**Re: Animal Shelter ASDRC Response**

Friar Project #: 2022-060A

As requested, below is a summary of changes to Glastonbury Animal Shelter in response to the commentary that Friar Architecture received at the January 17<sup>th</sup>, 2023 ASDRC meeting:

**Perspective Rendering**

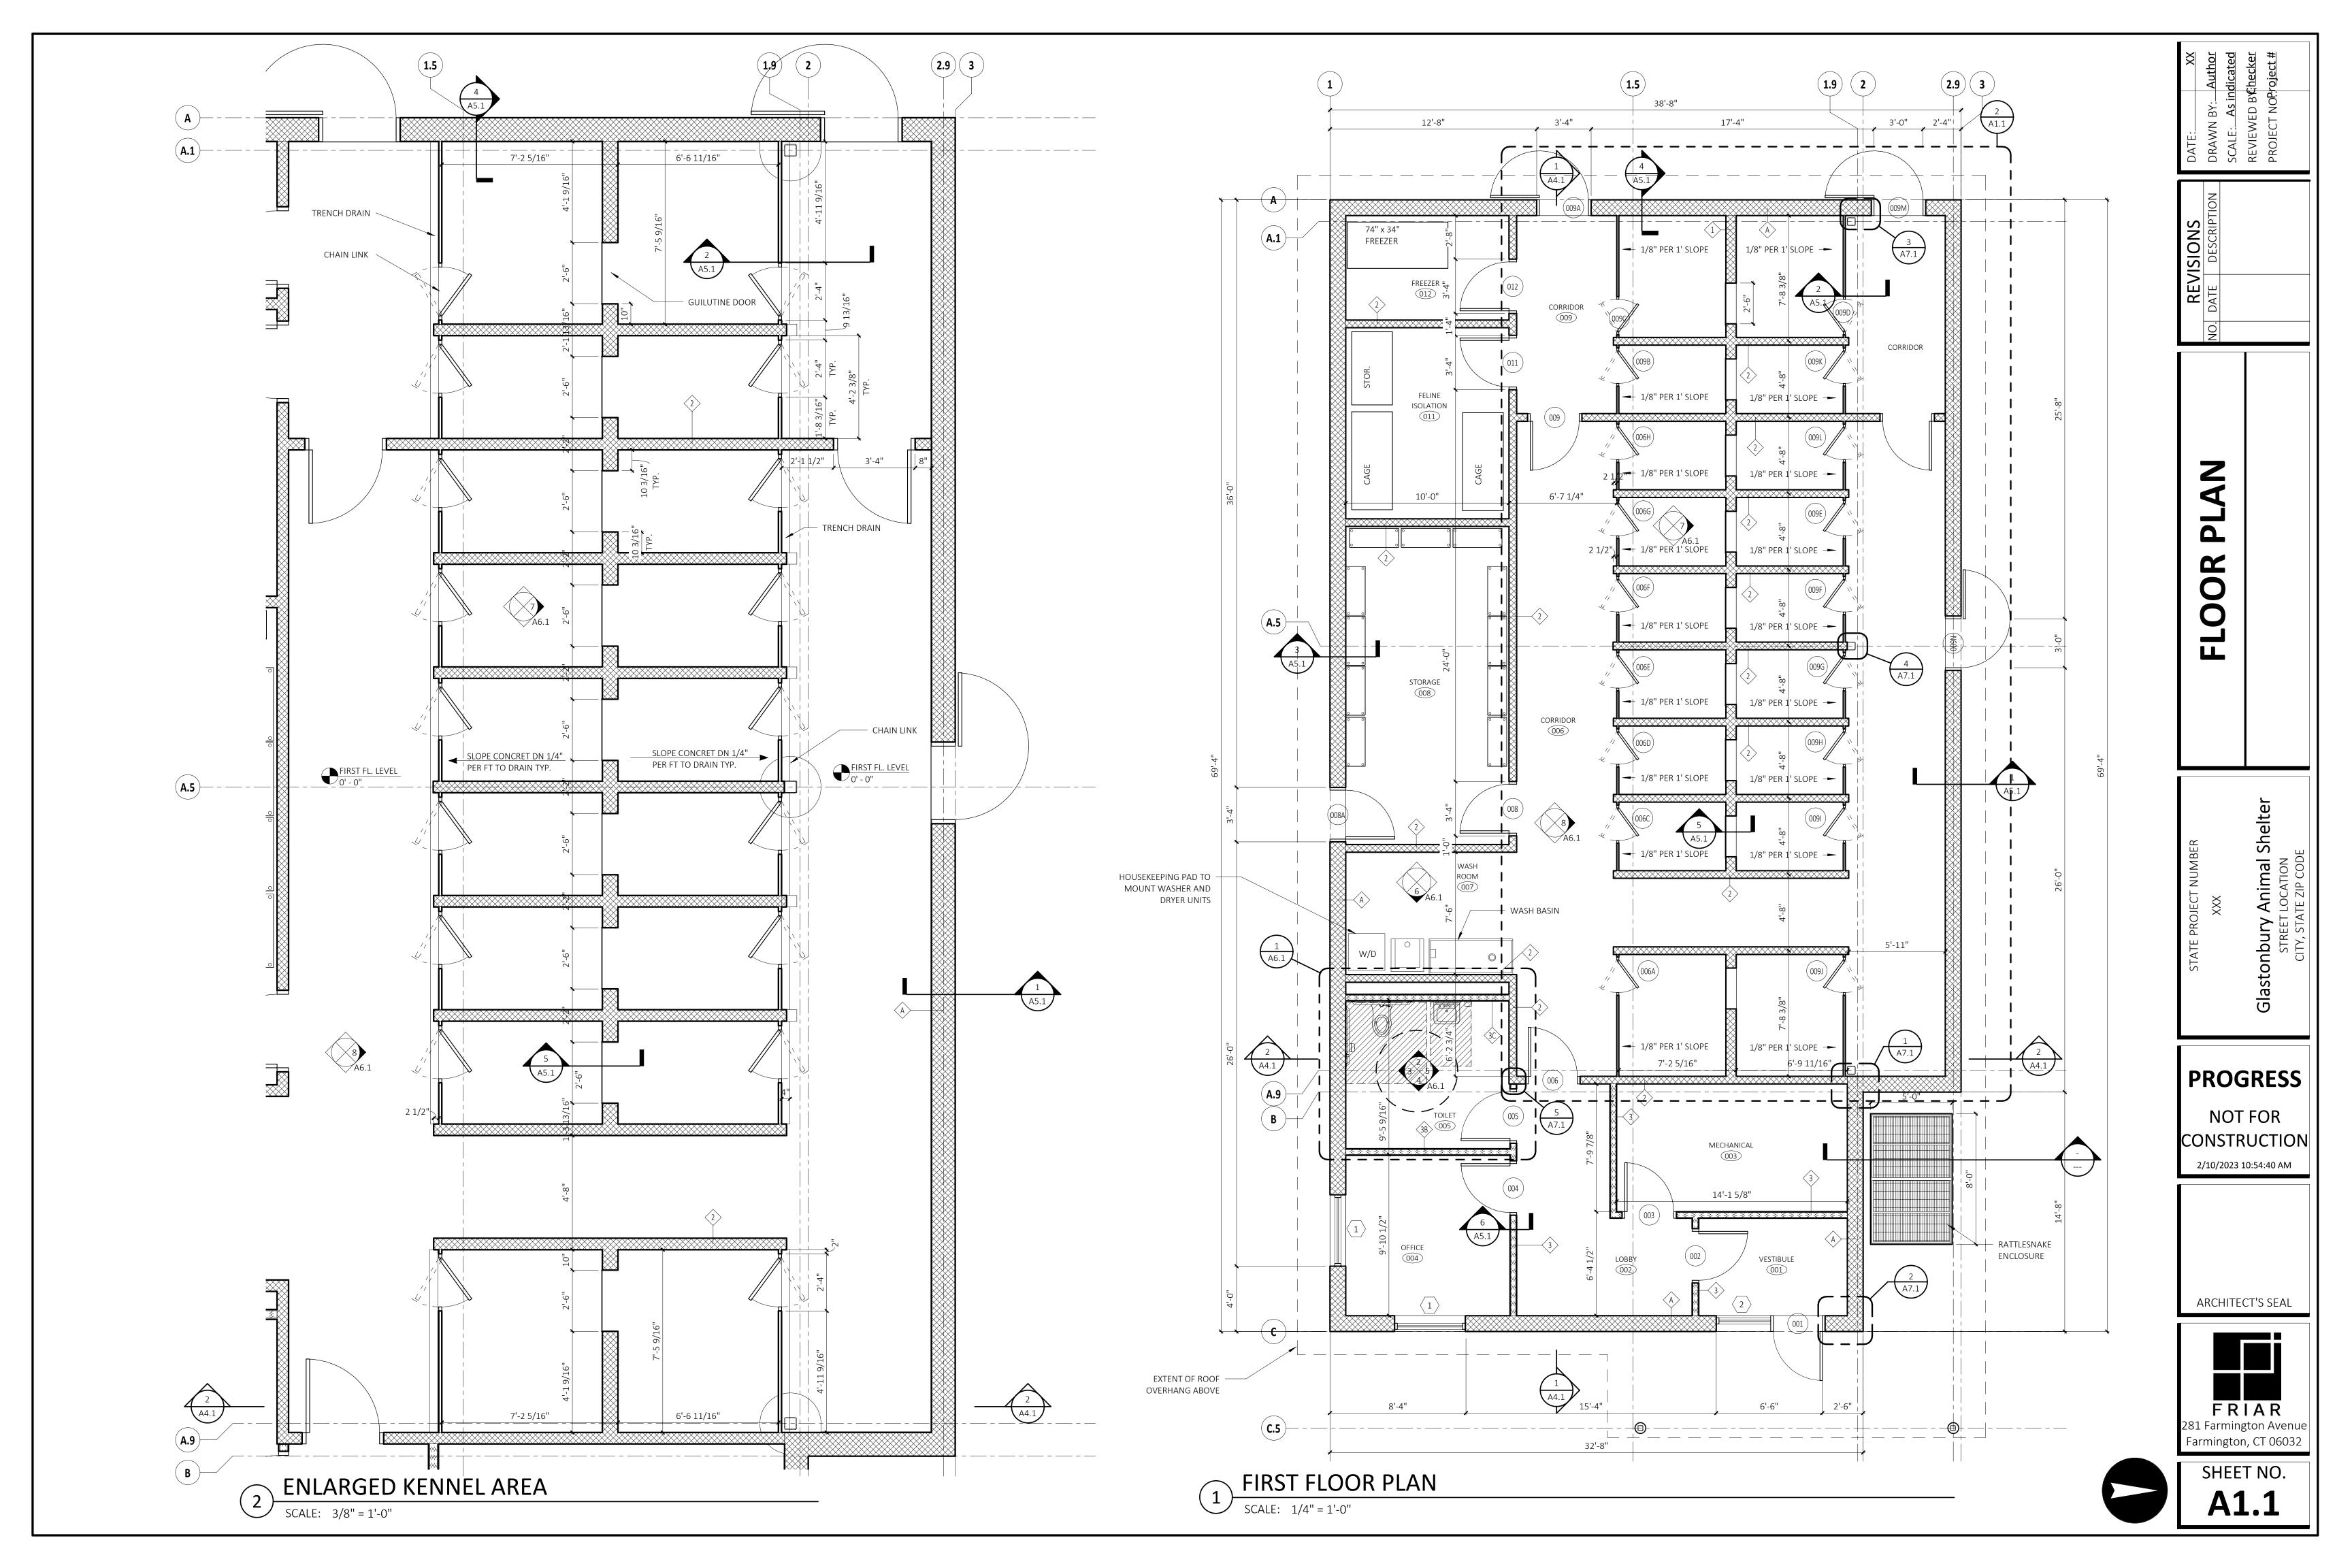
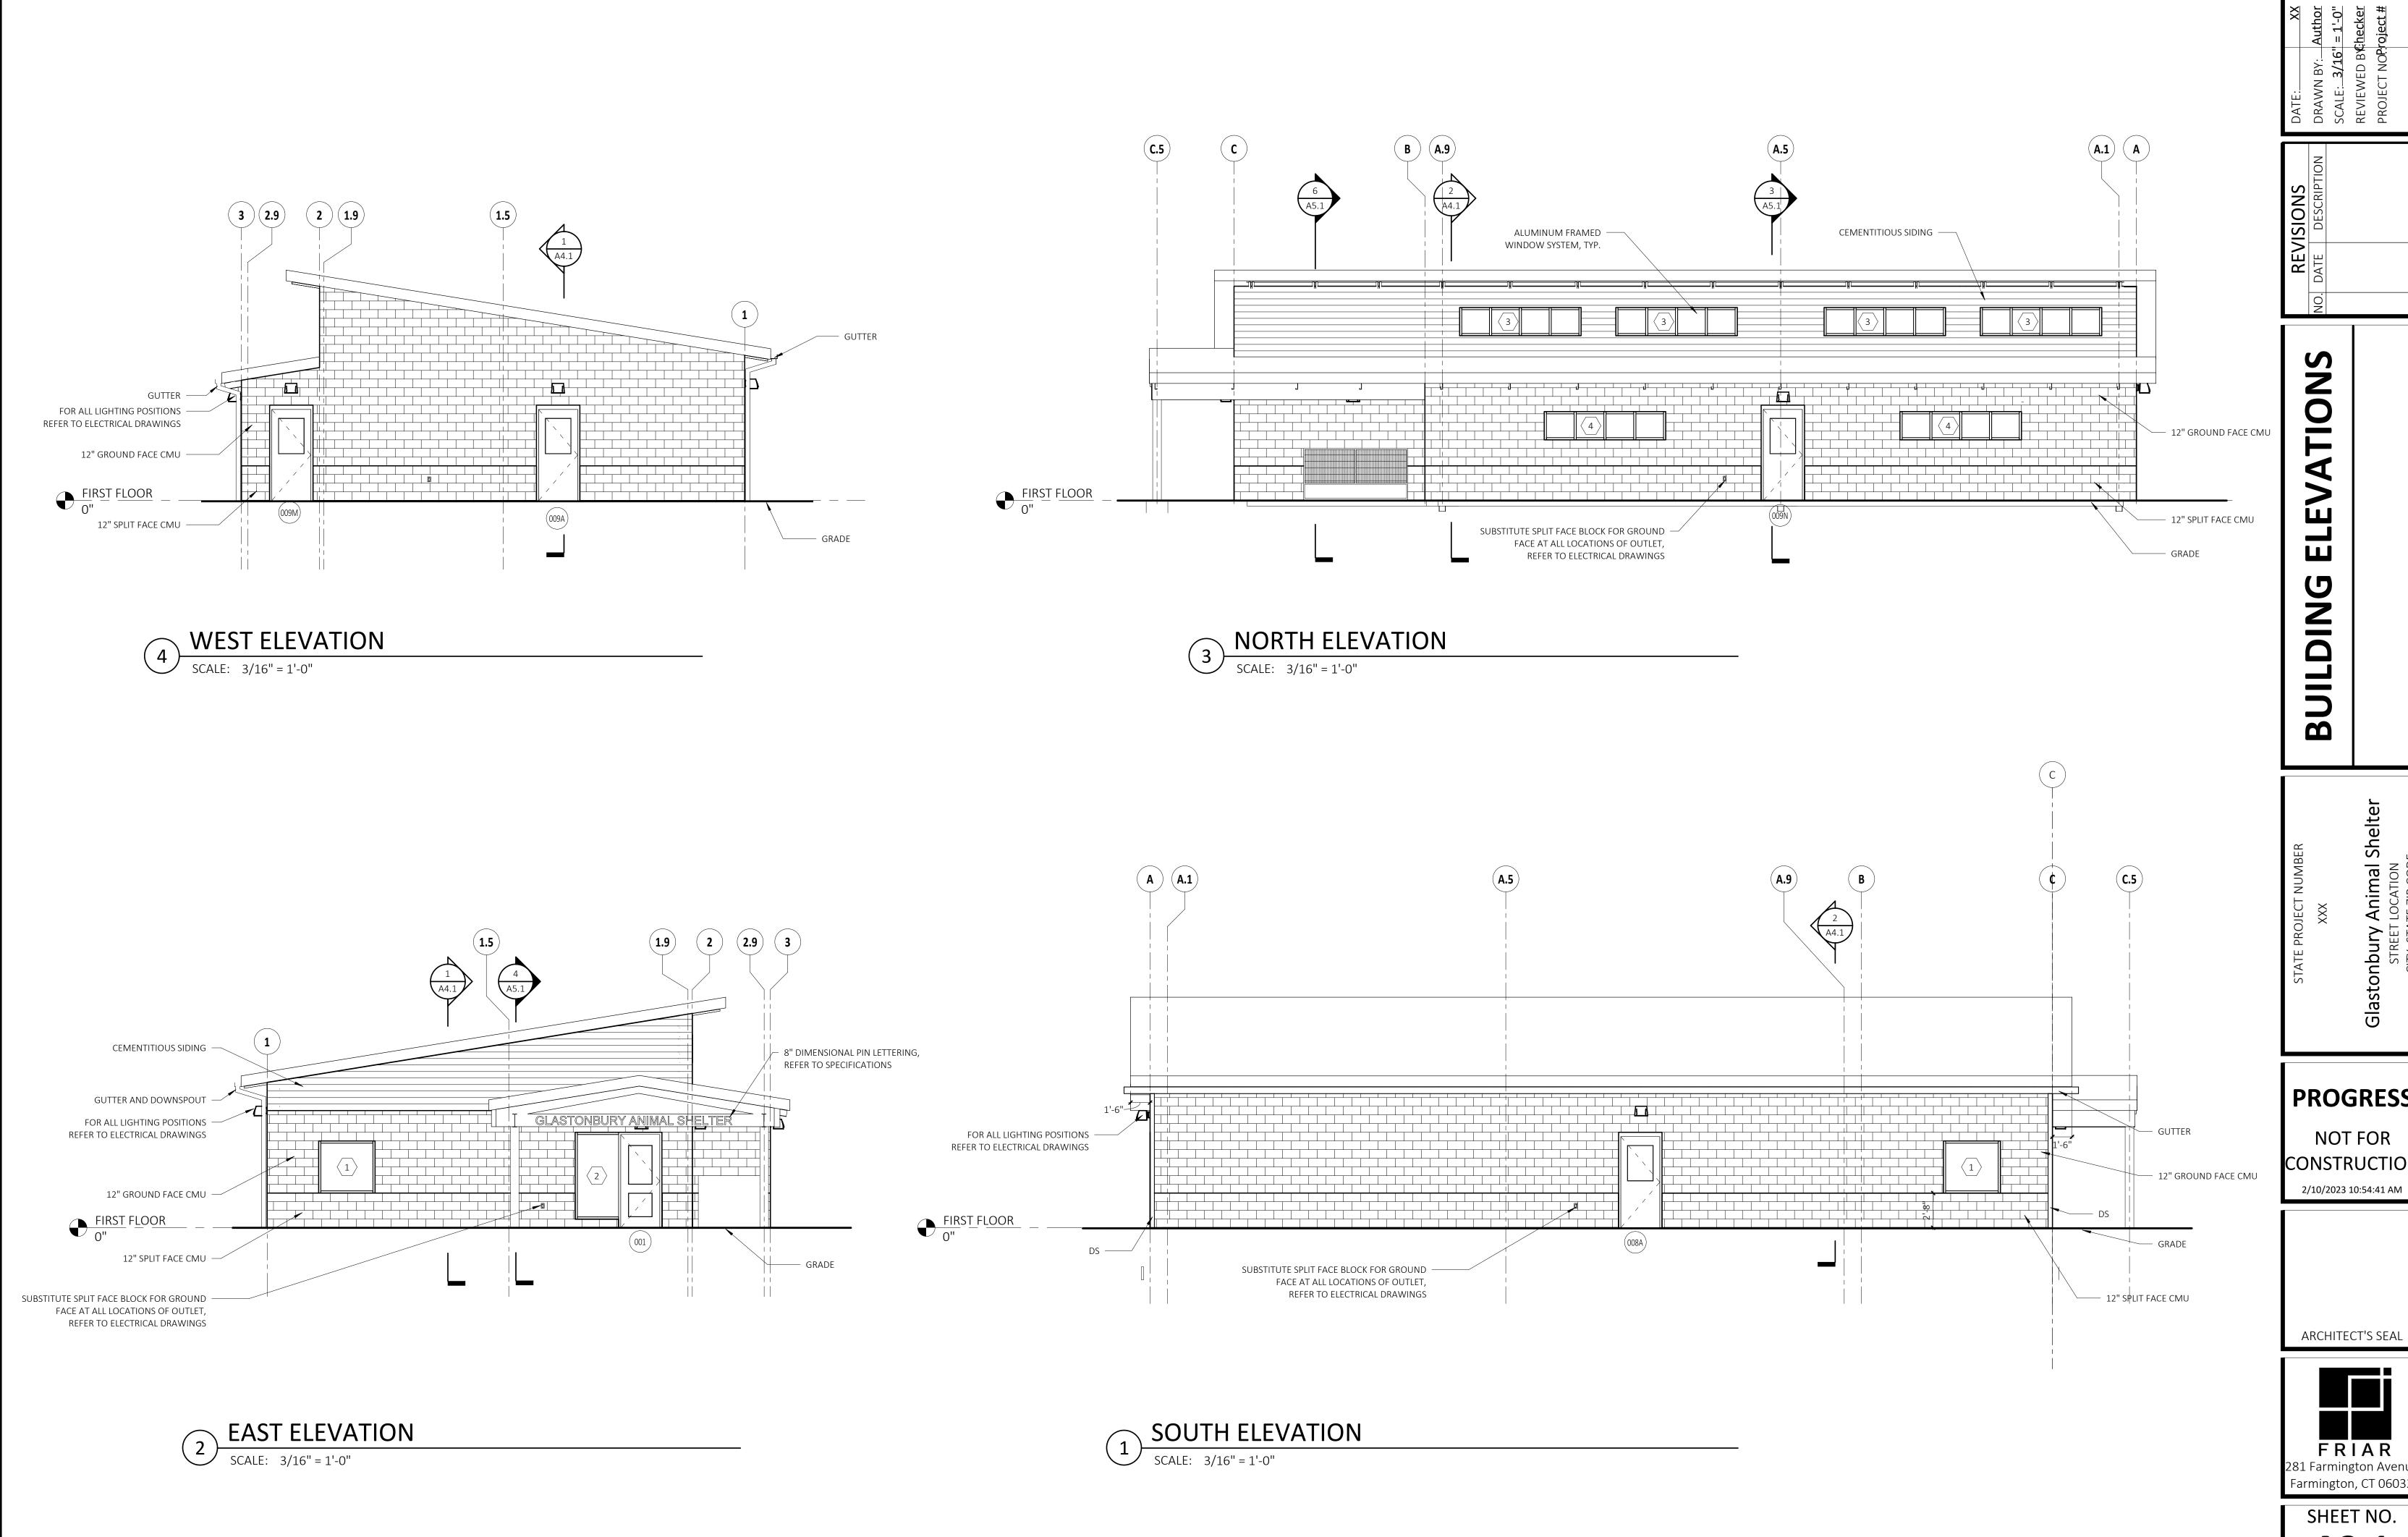
- Exterior CMU
  - Reduced height on north and east elevations. Replaced with a prefinished cementitious siding on metal stud backup above.
  - Changed all CMU material to one single color w/ a split face base to 32" above finished floor and ground face above.
- Window Fenestration
  - Revised the window locations and layout on the north elevation. Windows provided at kennel run corridor.
- Main Entry
  - Location of main entry defined further by locating the name of the facility above the entry portico. Main entry door changed to aluminum with glazed panels.
